Product Change Notification

Product Group: Aluminum Capacitors/February 15th, 2014/PCN-AC-501-2014 Rev 0 page1 of 2

Insulation & Marking of Axial Aluminum Capacitors, from dark blue PET to light blue PET case size 6,5 x 18 to 21 x 38 mm

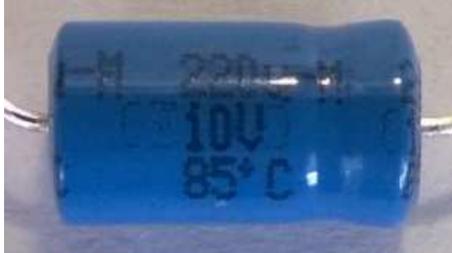
OLD: dark blue PET sleeve	NEW: light blue PET sleeve
